LAKE HAVASU CITY, ARIZONA
ADMINISTRATIVE SERVICES DEPARTMENT
◆ PROCUREMENT ◆

INVITATION TO BID
WATER MAIN REPLACEMENT PROJECT 2025
PROJECT NO. B26-PW-108037-500678
ADDENDUM NO. 3
JULY 31, 2025

Sheet Number: **WL07**

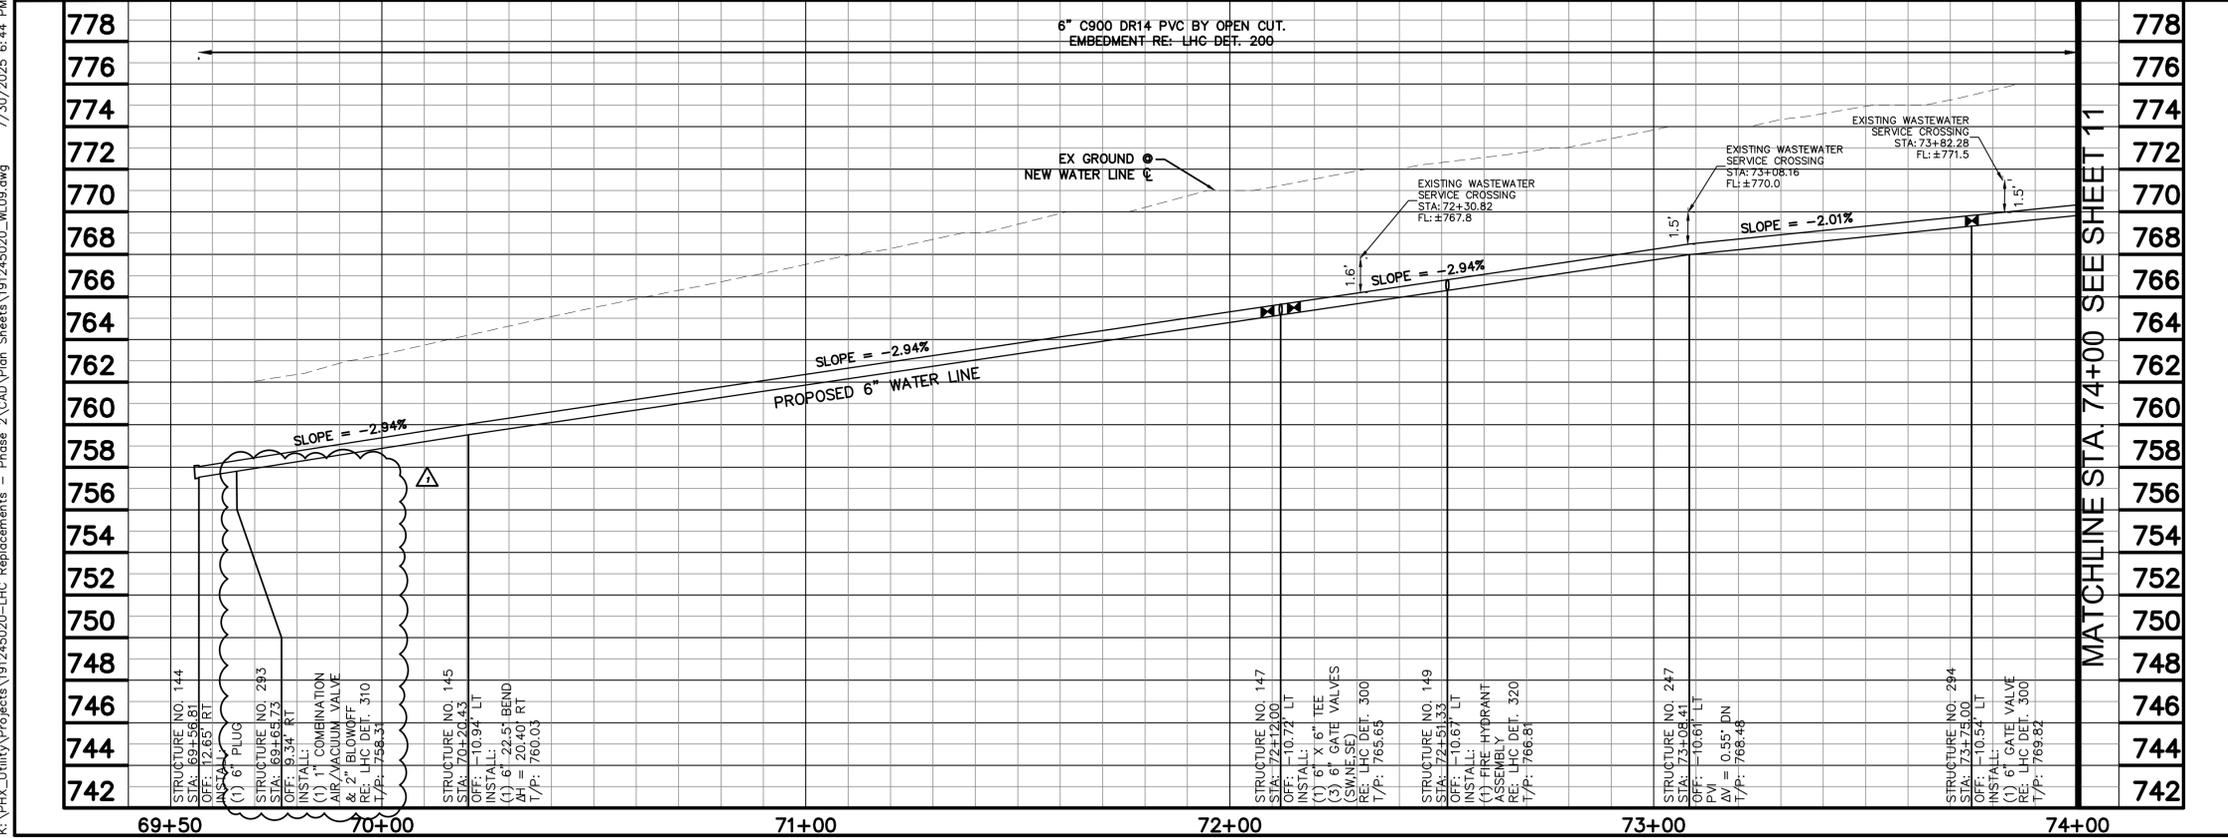
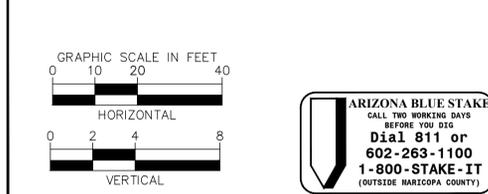
Question 7: *Please clarify the install of the water line around the structure at Pony Lane?*

Question 40: *Sheet WL07 shows a drainage structure at the end of the Cul de sac. Please provide a bid item for this scope and detail.*

Answer 7: An updated plan sheet WL07 has been included with this addendum (Attachment C). Service lines are to be routed around the storm structure to avoid impacts.

Answer 40: Refer to Answer 7.
